Amity College, Leppington Modification 2

State Significant Development Modification Assessment
(SSD-9227-Mod-2)

July 2021

Published by the NSW Department of Planning, Industry and Environment

Figure 6 | Stage 1 site plan – as approved (Source: SSD-9227 Approved Plans)

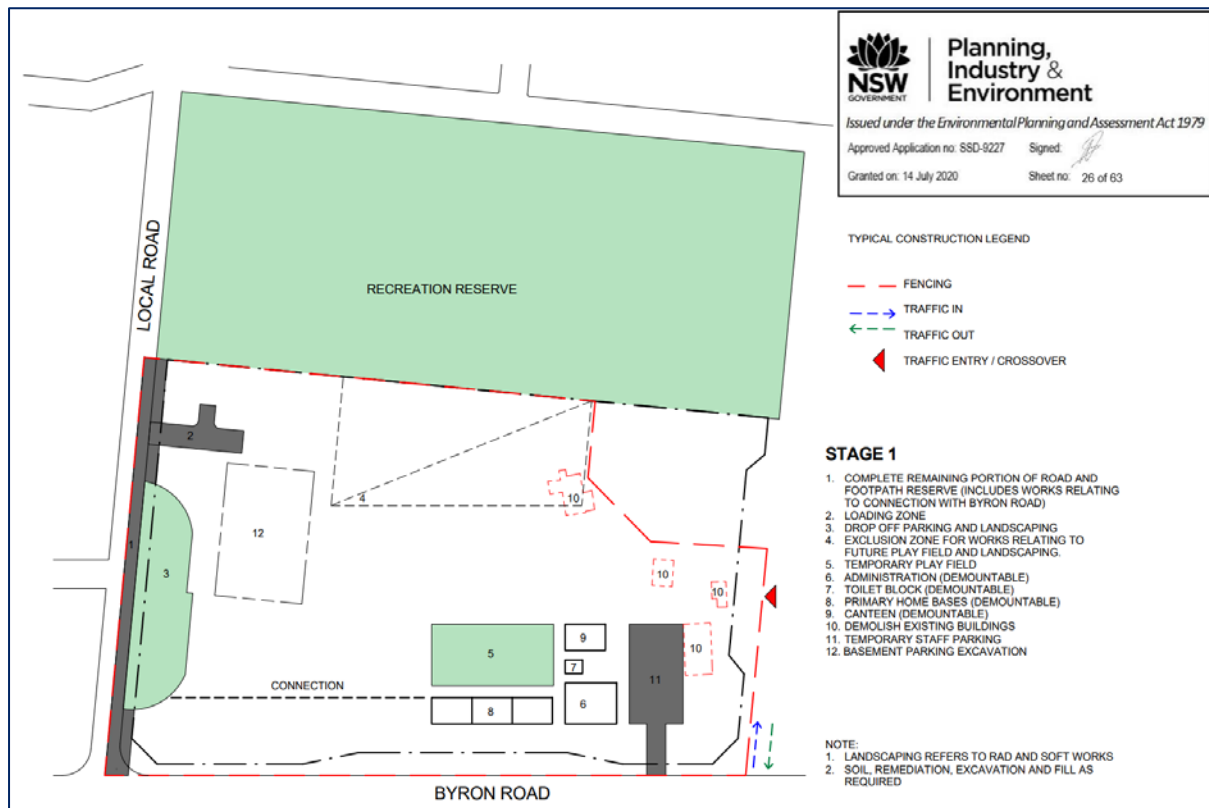
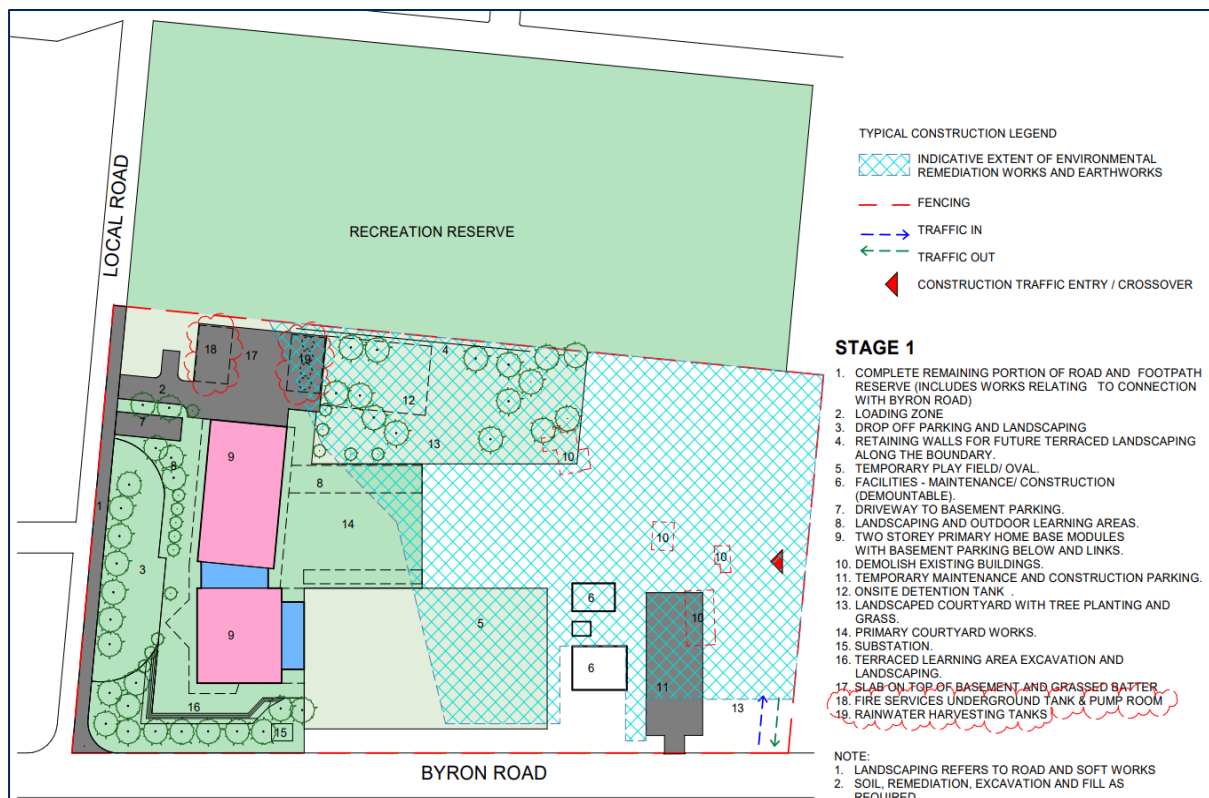
The sequence of proposed physical works and layout of the site, shown in comparison to the approved staging plans, is provided in **Figure 6 to Figure 17** (refer **Section 2.1**). The works approved in Stages 7 and 8 are sought to be undertaken in the earlier stages of the development and are, therefore, proposed to be deleted as part of the modification.

Stage 1 of the development, as proposed to be modified, would enable the Applicant to accommodate up to 300 primary school students and 24 staff and is an additional 225 students and 15 staff than what was originally approved for the first stage of the development.

The Department finds the proposed modification would enable the Applicant to expedite the provision of educational infrastructure and increase the student capacity in the earlier stages of the development, including 225 additional primary school placements at the commencement of operation.

In addition, the revised construction staging would ensure the primary school complex is developed in its entirety in Stage 1, therefore eliminating the need for temporary demountable classrooms and administration facilities on the site. The provision of civil infrastructure works approved as part of the original application would also be brought forward, including drainage and roadworks.

The Department notes the approved site layout (at project completion) would be maintained, and that no amendments are sought to the school's overall capacity of 1000 students and 85 staff. Accordingly, no significant environmental impacts are anticipated by bringing forward the approved construction staging or by the additional student enrolments in the earlier stages of the development.

Figure 18 | Approved Stage 1 extent of civil works (Source: SSD-9227 Approved Plans)

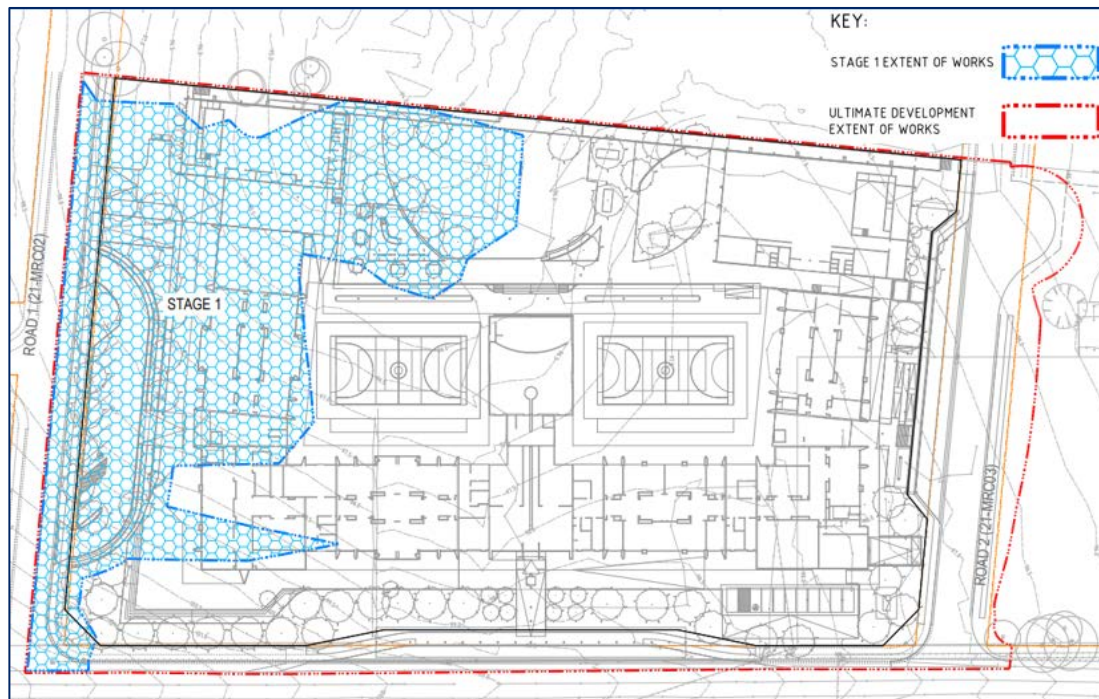
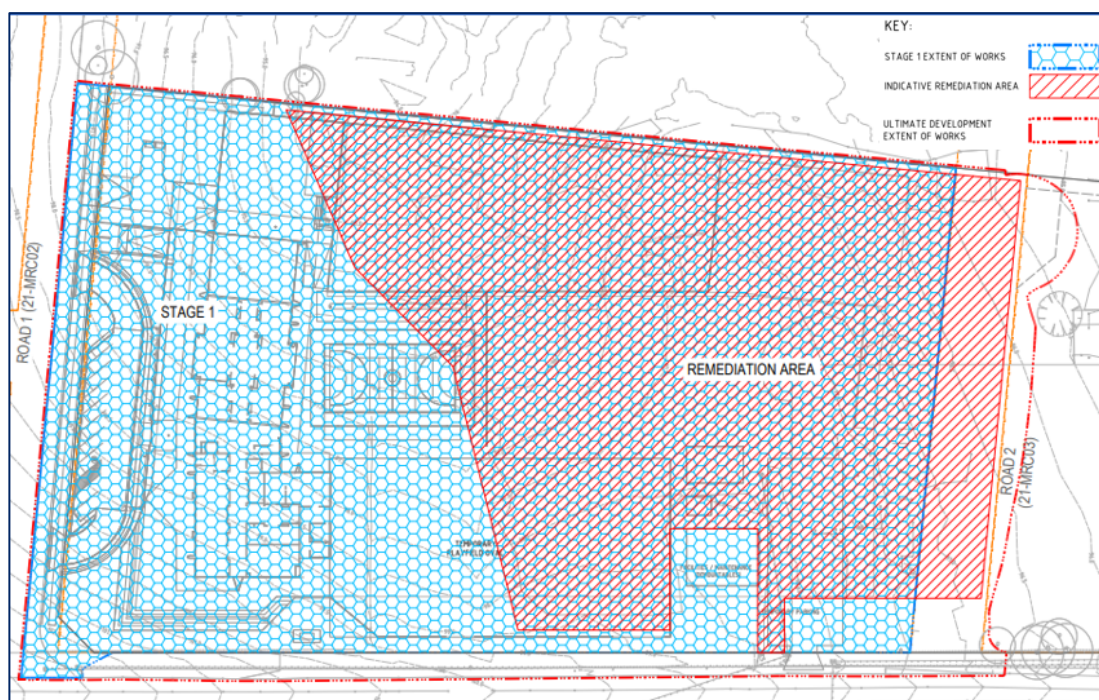
The Applicant's modification report confirmed that site remediation works commenced in November 2020 and are largely complete. However, the remediation investigations and excavation works revealed more widespread contamination across the site than previously thought, necessitating the need for approximately 2,000 cubic metres of additional soil to be removed, and which would need to be replaced to level the site.

In addition, the Stage 1 development footprint (including extensive site clearing and excavation works) would be increased as part of the modification in response to the accelerated project staging (discussed in **Section 6.1**). The Stage 1 development footprint, as proposed to be modified, is shown in **Figure 18** and **Figure 19** (refer **Section 2.2**).

The Department accepts the modification would result in a larger development footprint and additional site clearing than what was originally approved in Stage 1. However, it is noted that the full extent of site clearing and earthworks across the development site (i.e. all project stages complete) would remain consistent with what was originally approved. The Department therefore raises no concerns in response to the revised Stage 1 site clearing and earthworks.

The Department acknowledges that the approved package of civil engineering plans would need to be modified to reflect the revised project staging and extent of works in Stage 1. It is therefore recommended that the civil engineering plans under Condition A2 and the stormwater drainage plans under Condition C13 be updated accordingly.

Figure 20 | Proposed modifications at basement level (Source: Applicant's Modification Report)

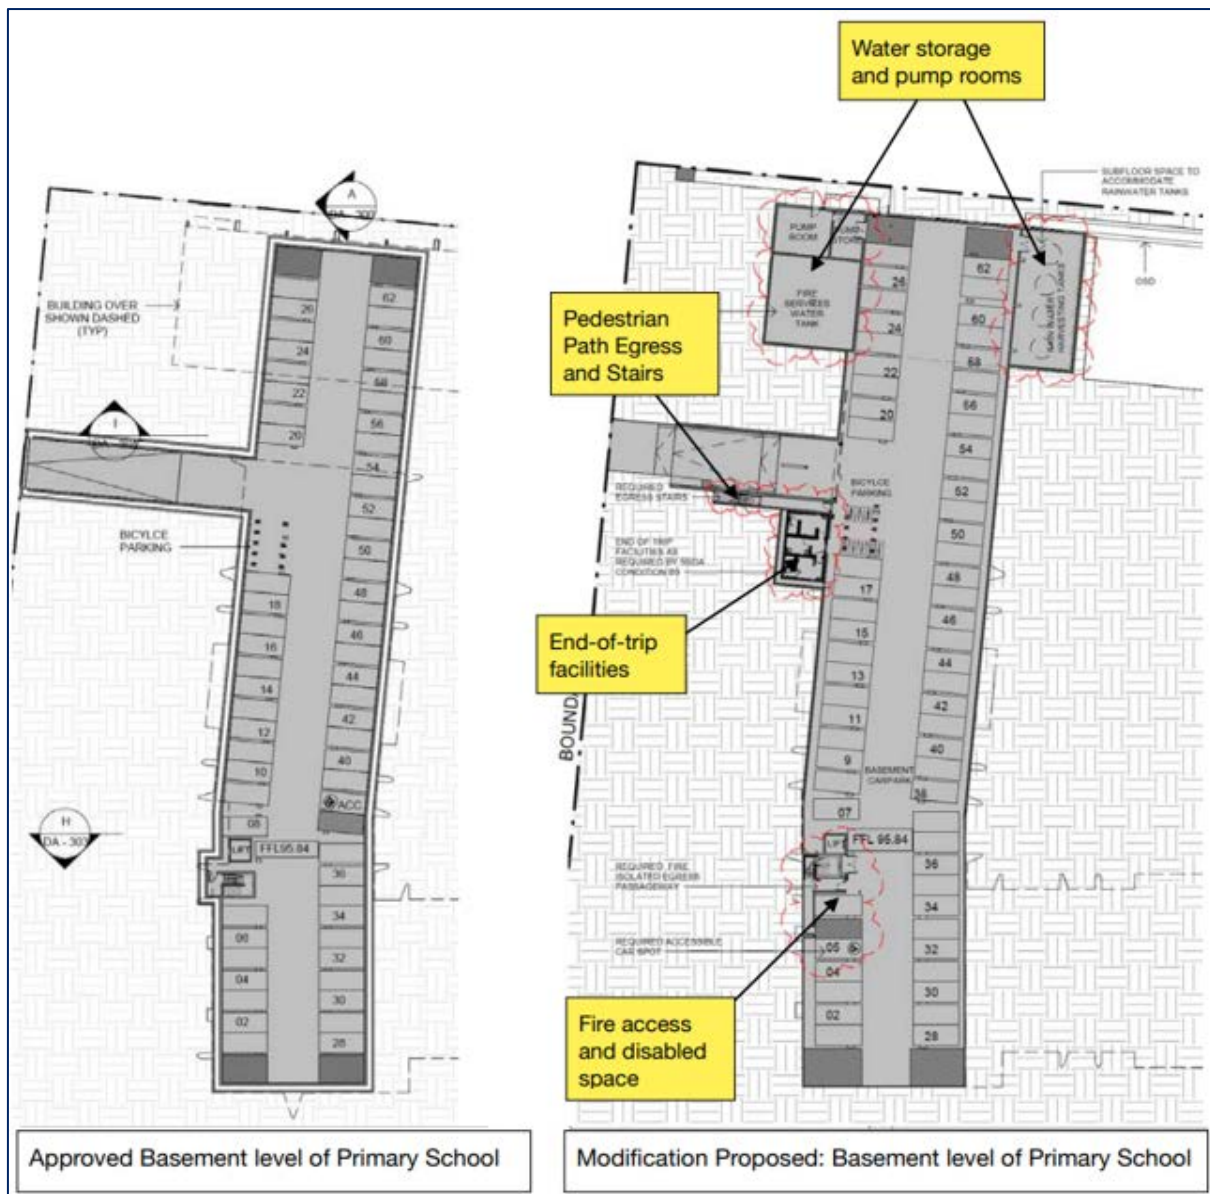
The proposed built form amendments include the provision of end-of-trip facilities and water storage facilities within the basement level of the primary school and minor reconfiguration of the GLAs and internal spaces at Level 1 at the south-eastern part of the building. The proposed amendments are shown in **Figure 20** and **Figure 21** (refer **Section 2.2**).

- Condition B9, which requires end-of-trip facilities be provided for staff and for the design of the basement car park to comply with the Australian standards for off-street car parking facilities (AS2890.1) and accessible car parking (AS2890.6).
- Condition B10, which requires the basement car park to include a pump-out system that has been designed in accordance with the Australian standards for stormwater drainage (AS3500.3.2–1998).
- Condition C20, which requires a rainwater reuse/harvesting system to be incorporated as part of the development.

The built form amendments would result in an additional 76m² of gross floor area (GFA), beyond what was originally approved for the site. This includes an additional 47m² attributed to the end-of-trip facilities at the basement level and an additional 29m² attributed to the minor reconfiguration of the GLAs and internal spaces at Level 1.

The Department acknowledges the proposed amendments to the basement level of the building are required to ensure compliance with the conditions of consent and the relevant Australian standards. No concerns are raised in response to the minor additions to the GFA at the basement level.

Figure 22 | Proposed modifications – southern facade (Source: Applicant's Modification Report)

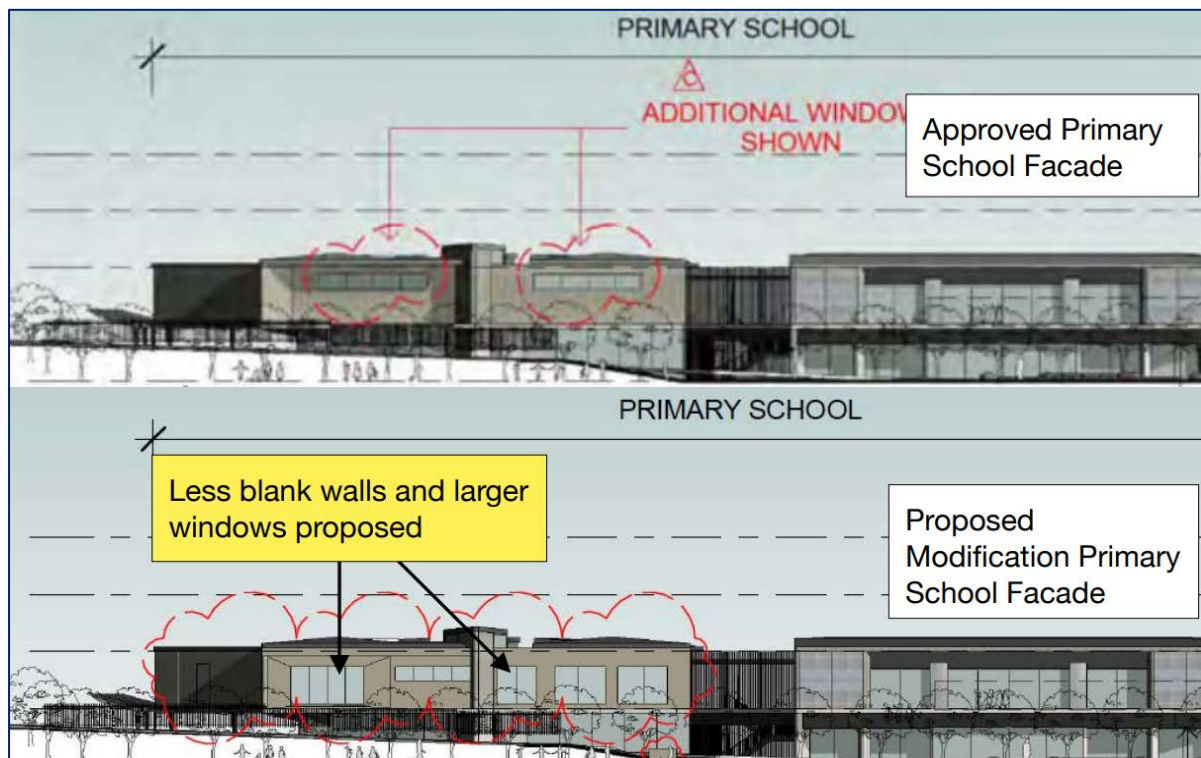
The Department accepts Applicant's justification that the minor amendments proposed to the southern facade of the building and inclusion of larger windows would improve the visual appearance of building, when viewed from Byron Road.

Figure 24 | Stage 1 landscape plan – as approved (Source: SSD-9227 Approved Plans)

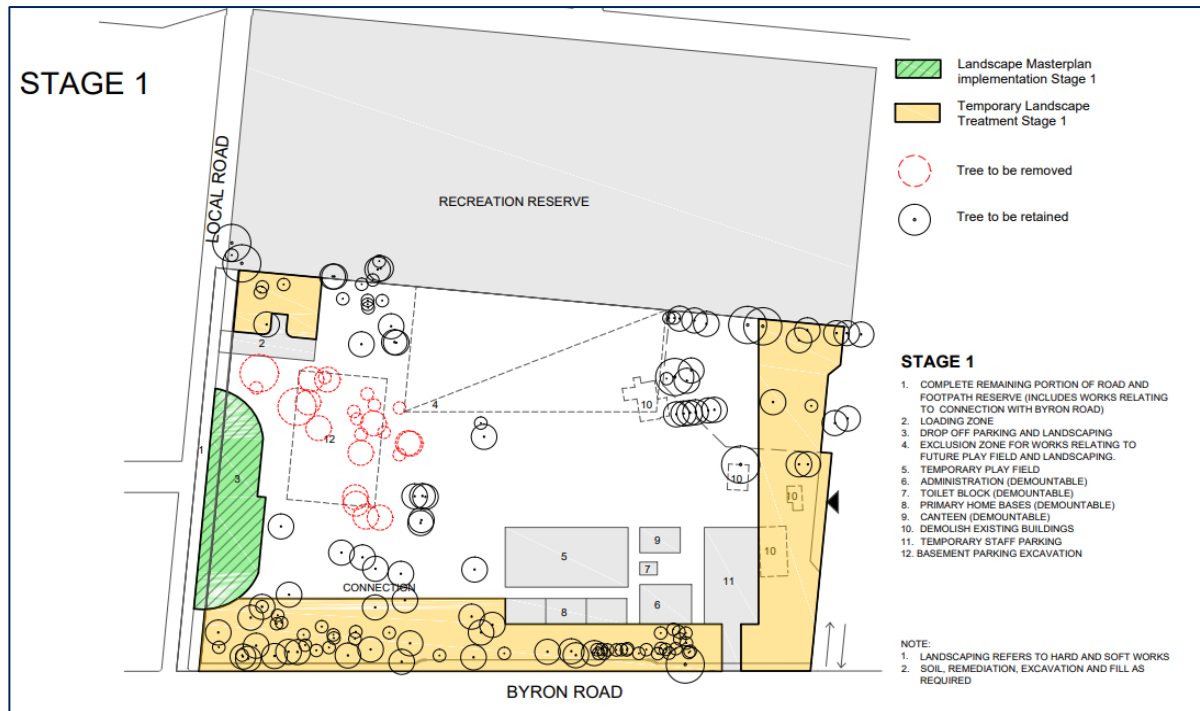
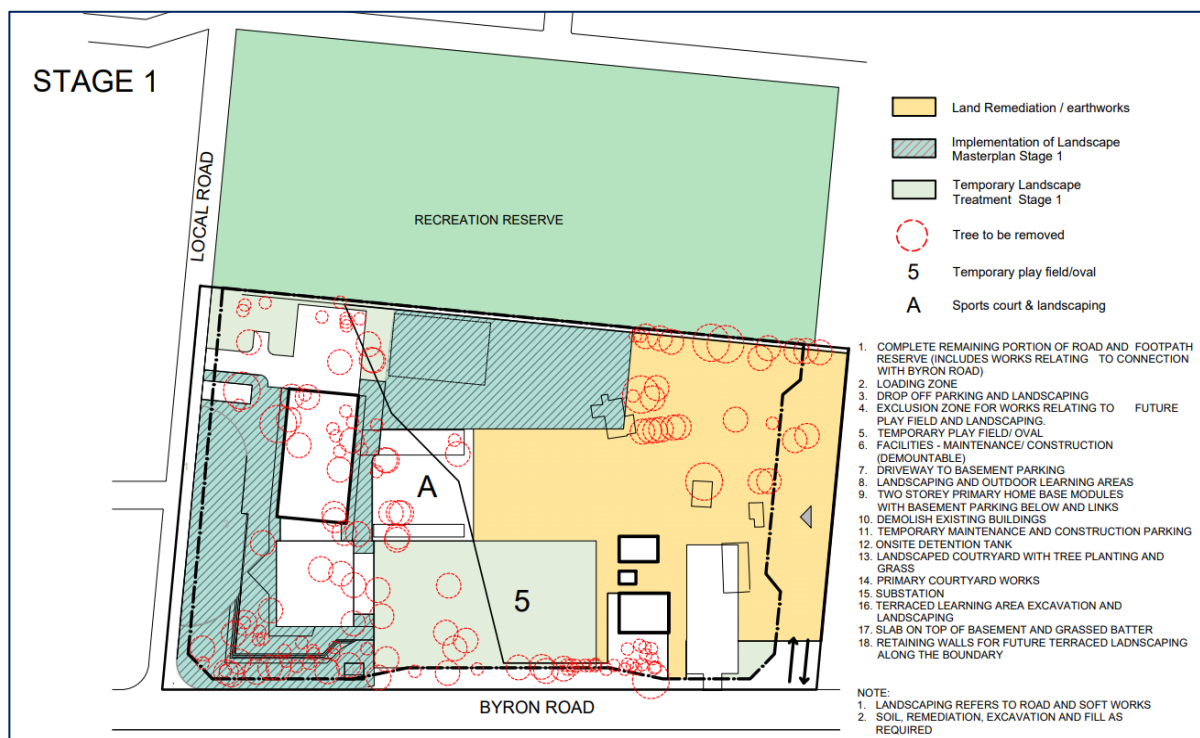
The Applicant's modification report stated that the landscaping plans approved as part of the original application largely involved temporary landscape treatments in the interim stages of the development and do not reflect the extent of vegetation clearing that has occurred as part of the site remediation works. Extensive and permanent landscaping is therefore proposed from the commencement of operation (in Stage 1), rather the provision of temporary landscaping treatments on a stage-by-stage basis as the site develops.

The Applicant's modification report stated that the early establishment of permanent tree plantings at project commencement would provide a 'green link' between the school site and the future public open space area adjoining the school to the west, as well as providing a 'green edge' to the two street frontages.

The Department supports the proposed modifications to the approved landscaping plans and considers that the provision of permanent and extensive landscaping from the commencement of operation would provide a positive outcome for the site and the surrounding locality. The Department also supports the proposed 328 m² of additional landscaped area and equivalent reduction of impermeable surfaces previously attributed to internal walkways and car parking areas.

Figure 27 | Proposed site landscaping at project completion (Source: Applicant's Modification Report

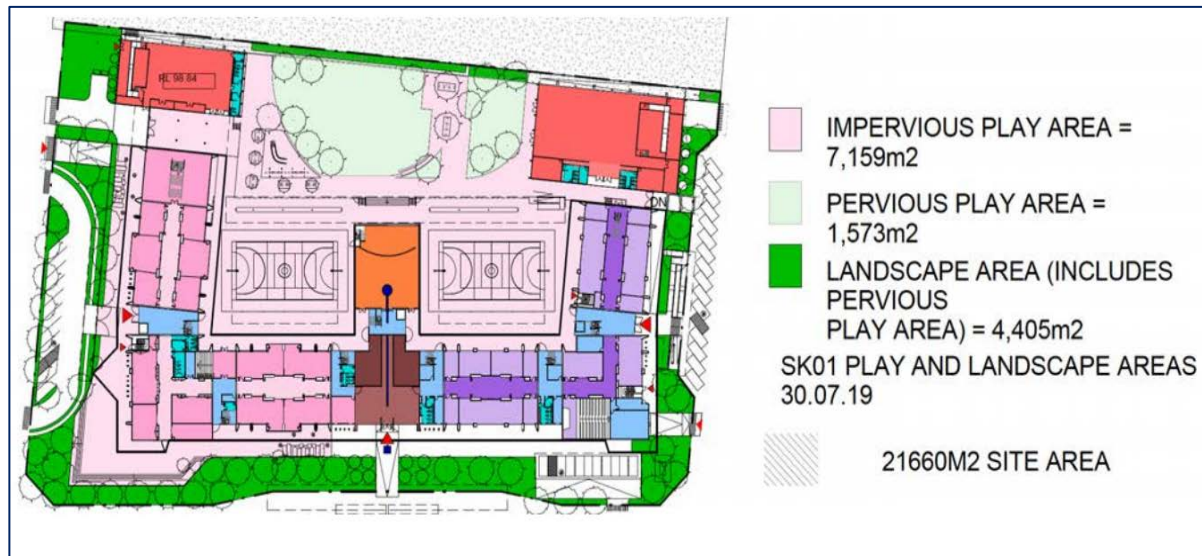
The revised design also provides for an overall increase in landscaping and a reduction in hard surfaces including walkways and parking areas, as shown in **Table 3**.

The extent of landscaping, impervious and pervious play areas on the site (as proposed to be modified) is shown in **Figure 27**. The broader landscape masterplan for the site (as proposed to be modified) is shown in **Figure 26** (refer **Section 2.4**).
